## ADDENDUM #1

Reference: Developmental Center Auditorium Re-roof  
State Developmental Center – American Fork, Utah  
DFCM Project No. 08196410

## **ADDENDA #1**

PL-101

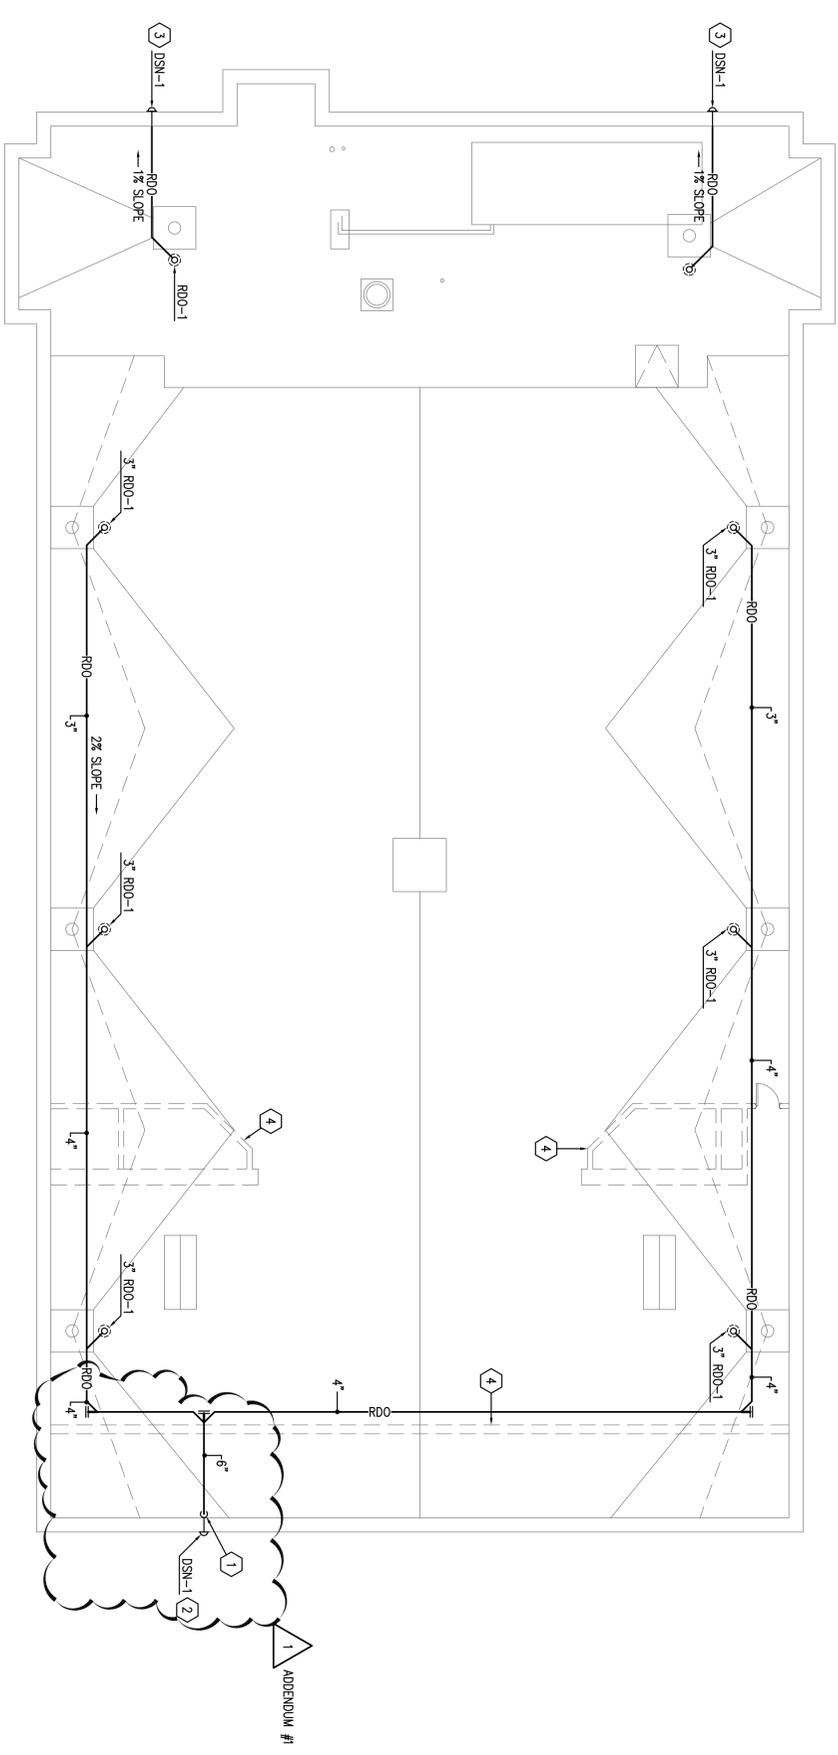
#### **DRAWING PL-101 – ROOF PLUMBING PLAN**

- Revise location of secondary drain line drop approximately 8'ft north on east exterior wall and drain pipe to penetrate east wall at bottom of drain pipe drop. Verify exact location with Architect on jobsite in existing corridor. See attached drawing PL-101.

- DROP ROOF DRAIN OVERFLOW DOWN IN CORNER OF CORRIDOR. FIELD DETERMINE EXACT LOCATION OF DROP. COORDINATE WITH EXISTING CONDITIONS AND NEW FINISHING.
- INSTALL DOWNSPOUT NOZZLE APPROXIMATELY 12"-16" INCHES ABOVE GRADE. FIELD DETERMINE.
- INSTALL DOWNSPOUT NOZZLE UP HIGH.
- EXISTING MASONRY WALLS.
